**"ALTA/ACSM LAND SURVEY YOUTH CENTER, ODANAH, WI" ADDITIONAL INQUIRIES AND RESPONSES**

# Proposed Site Option C Location for the Boys and Girls Club Planned Facility

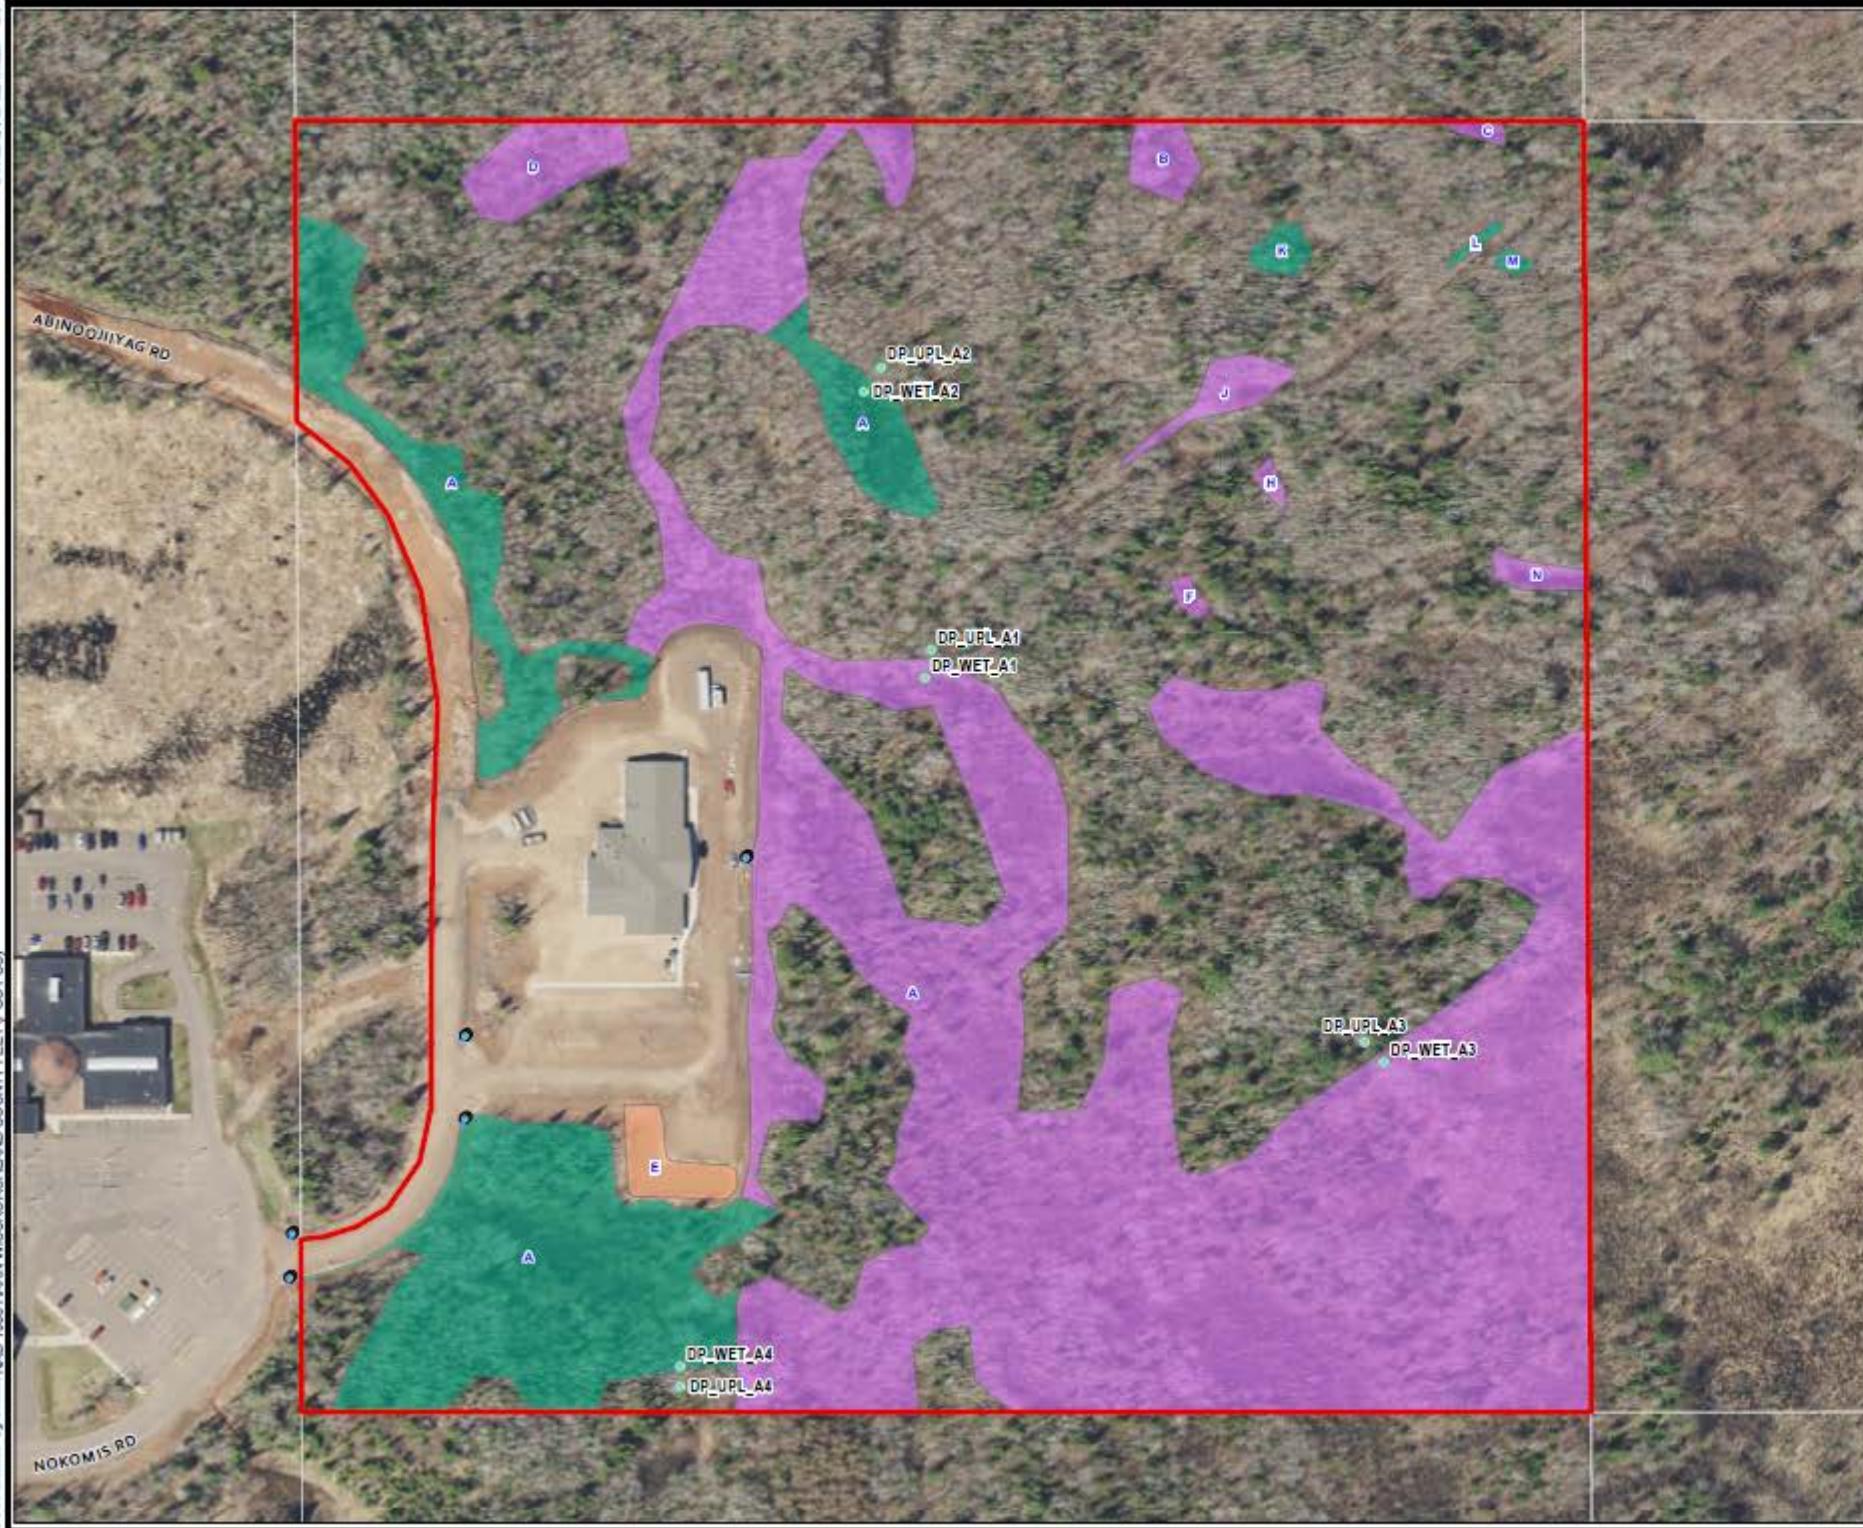
**Q2 – Can you confirm that the proposed site is currently undeveloped? I looked up the location and noticed that there is an existing building in that quarter-quarter section.**

A2: You are correct in recognizing that there is an existing building within that site, but we intend for the new development to be built to the north of that campus, within that parcel but with final site boundaries of about 2.5 Acres which may need to be adjusted based on the site design. I've attached a map that shows an approximate outline of the proposed new building to clarify specific location.
